SUBJECT: THREE MILE ISLAND, UNIT 2, ISFSI – NRC INSPECTION OF THE  
INDEPENDENT SPENT FUEL STORAGE INSTALLATION - INSPECTION  
REPORT 07200020/2012-001

Report: 072-020/2012-001

Facility: Three Mile Island, Unit 2, Independent Spent Fuel Storage  
Installation

**Before and After Photographs of HSM Concrete Repair**

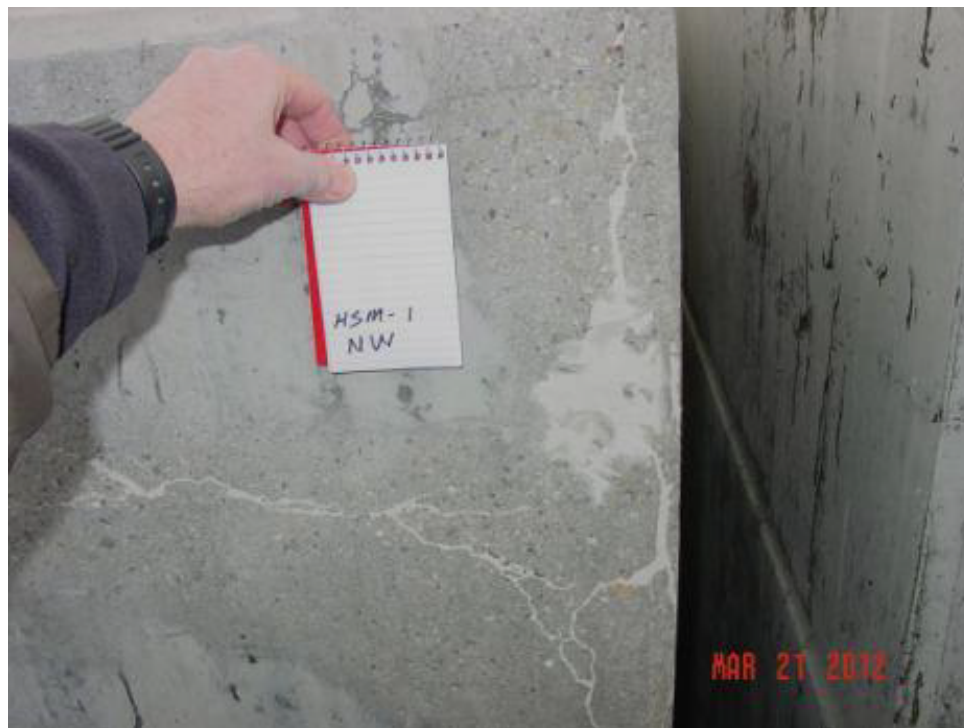
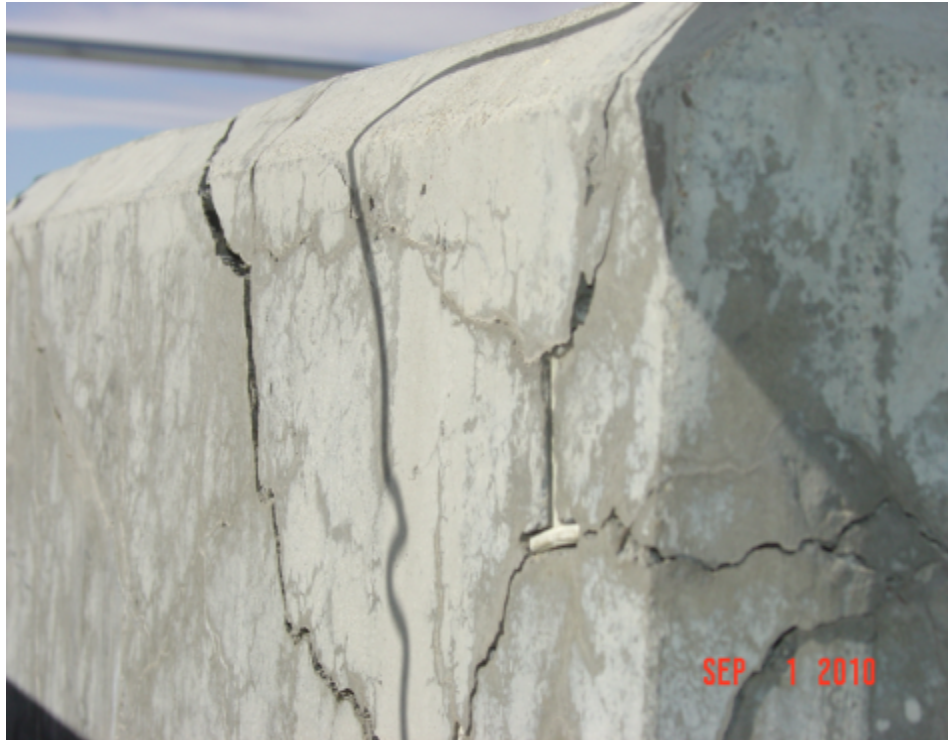
An inspection of the repaired areas of the HSM concrete revealed that over the course of the first freeze/thaw cycle, the resin injections were holding up very well. Selected photographs of the HSM concrete before the repair and after the resin injection are shown in Attachment 2.
